Planning Commission Meeting

- 4.I. 240 Mt. Zion Road Site Plan Review

**DEPARTMENT OF PLANNING AND ZONING
PLANNER'S REPORT**

DATE: February 2, 2022
TO: Adrienne Senter
FROM: Lynn Patterson
RE: **Site Plan Review – 240 Mt Zion Road**

C-1

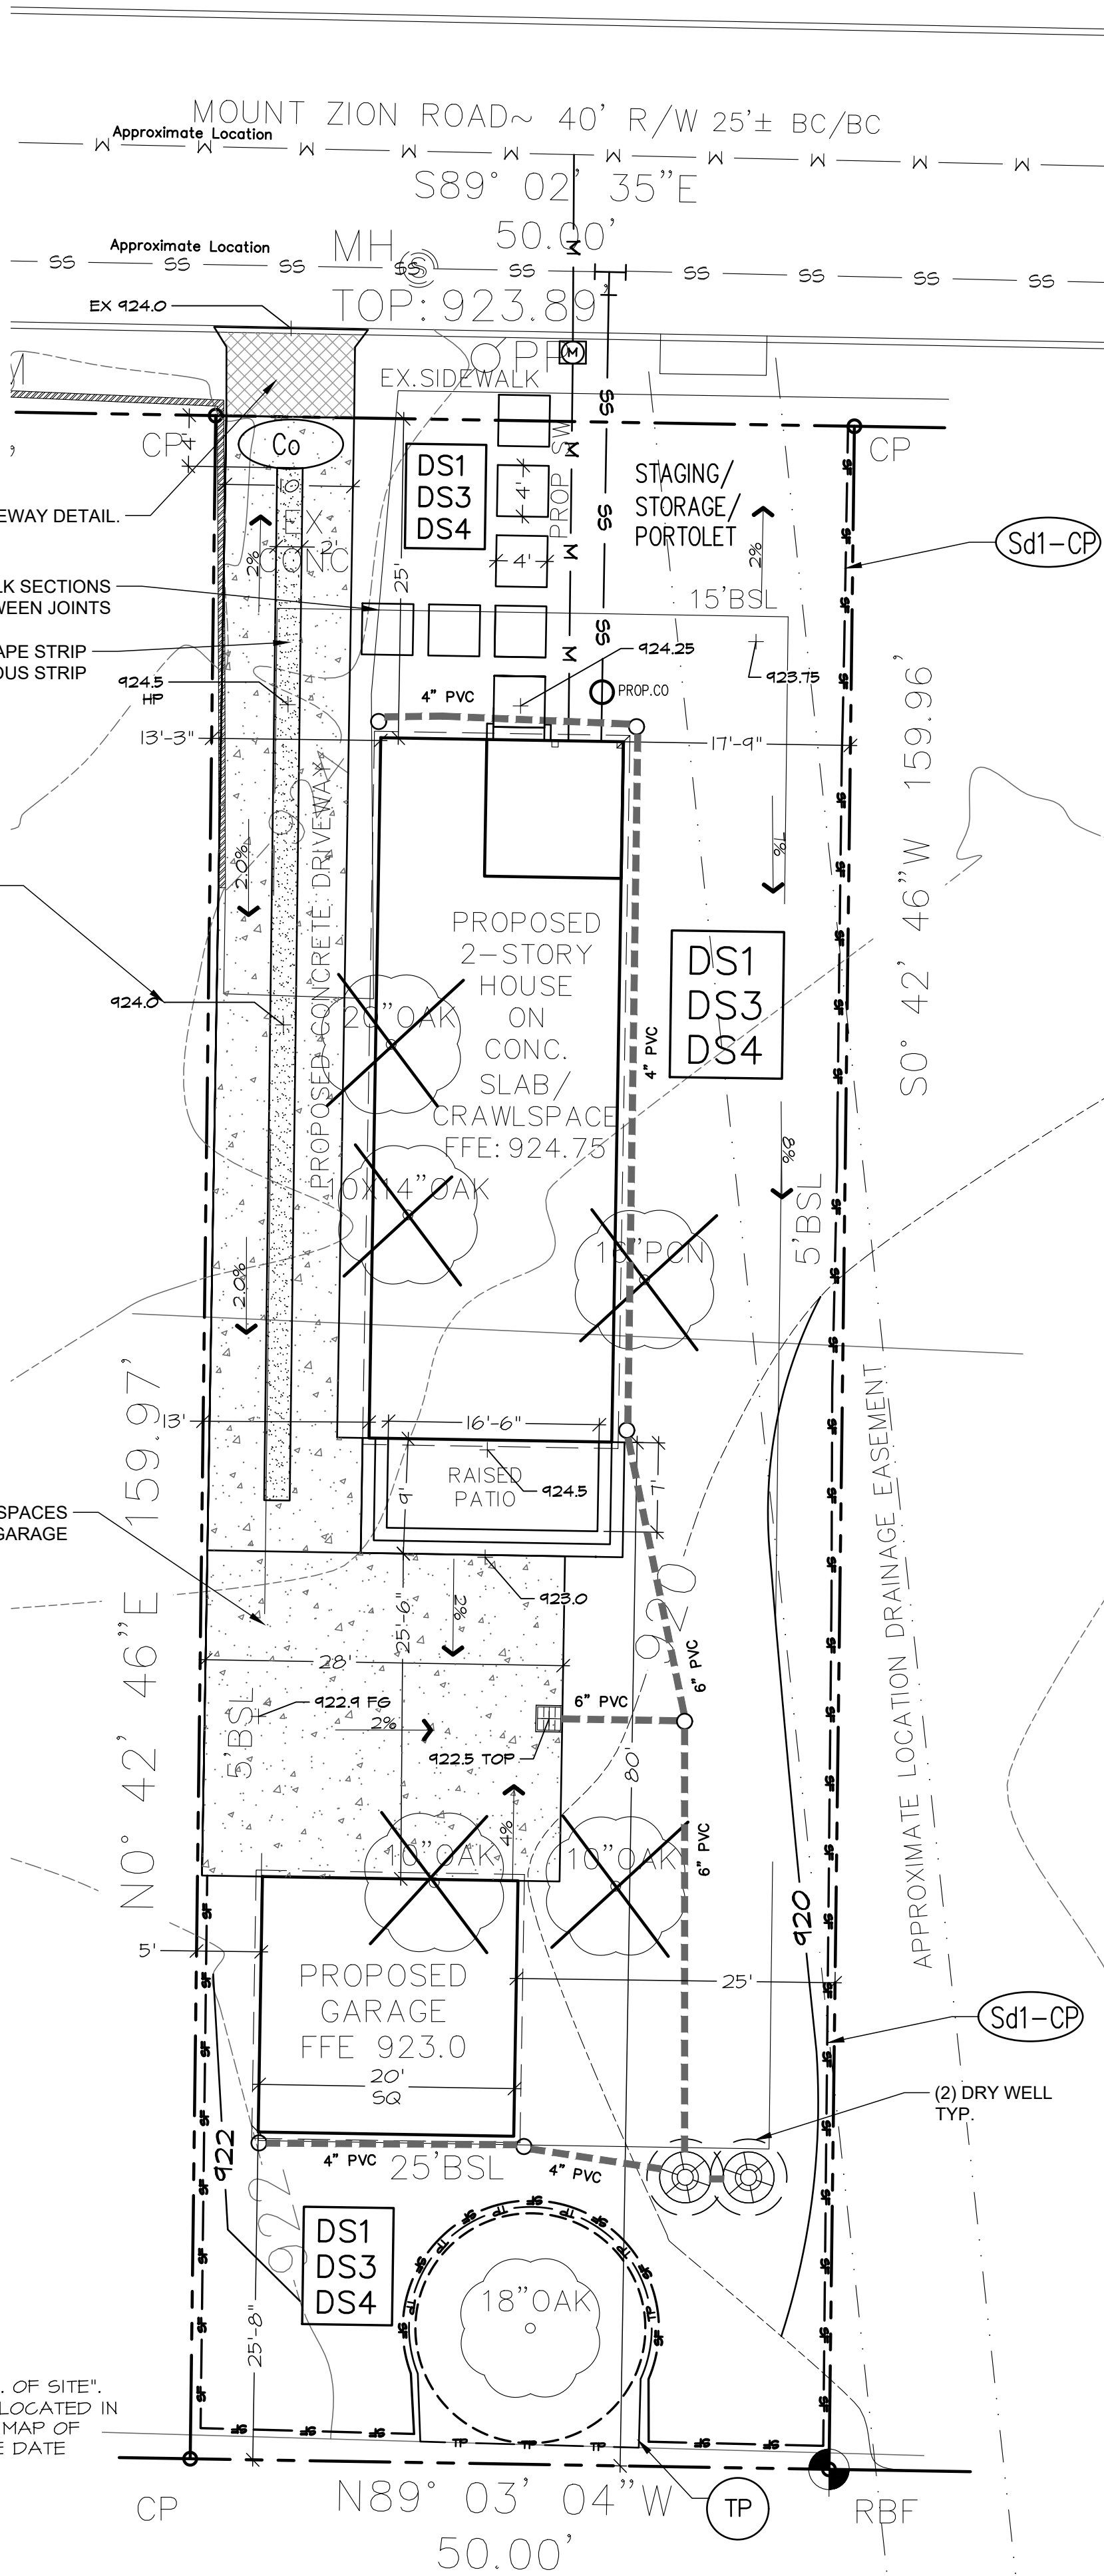
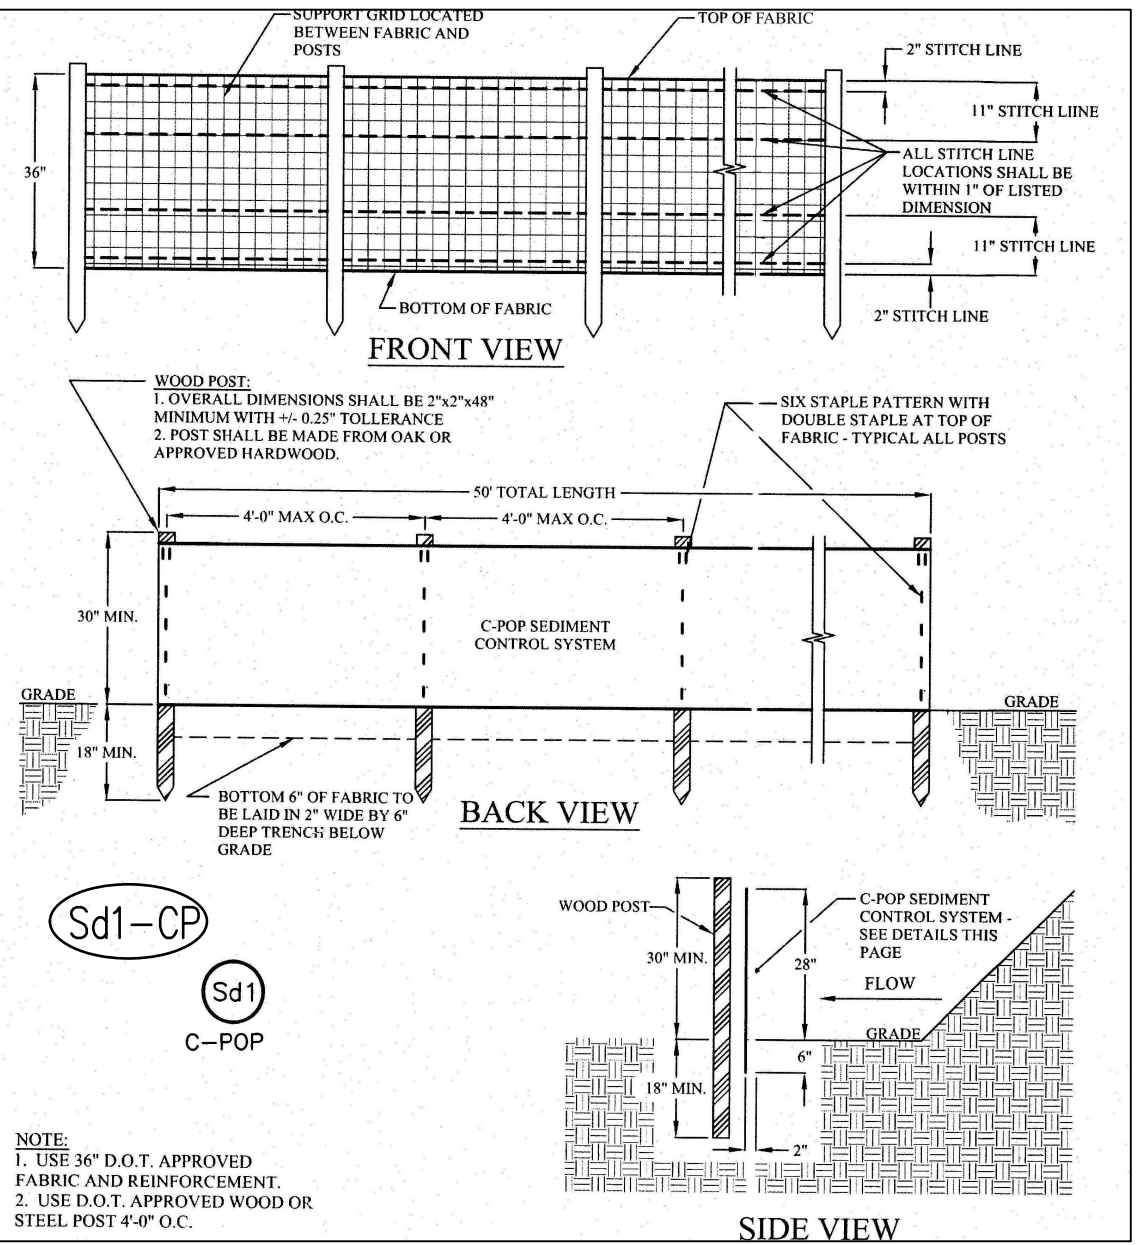
- ***The plans show the location of a new two story, single-family dwelling with an undetermined square footage. Correct square footage should be provided.***
- ***Per the project data, the structure will be 23' 11" not including the foundation. The garage is shown as 14' 5 ½" high.***
- ***Setback dimensions of the new primary structure are as follows:***
 - ***Front setback is 25'***
 - ***Side setbacks are 13' and 17' 9" and 5' to the detached garage*.***
 - ***Rear setback is 71' to the raised patio and 25' 8" to the detached garage***
 - ***The distance between the dwelling and the detached garage is 25' 6***
- **** The site plan should confirm that no structure on adjacent lot is closer than 10' from the detached garage.***

- d. Floor area in nonresidential use by category.
- ***Not applicable.***
- e. Total floor area ratio and/or residential density distribution.
- ***The minimum required floor area is 1,000 SF. The proposed dwelling square footage should be provided on the site plan.***

- Provide proposed dwelling square footage on site plan.
- Confirm no structures on adjacent lots are closer than 10' from detached garage.
- Address any outstanding issues in the arborist report.
- Provide development schedule.
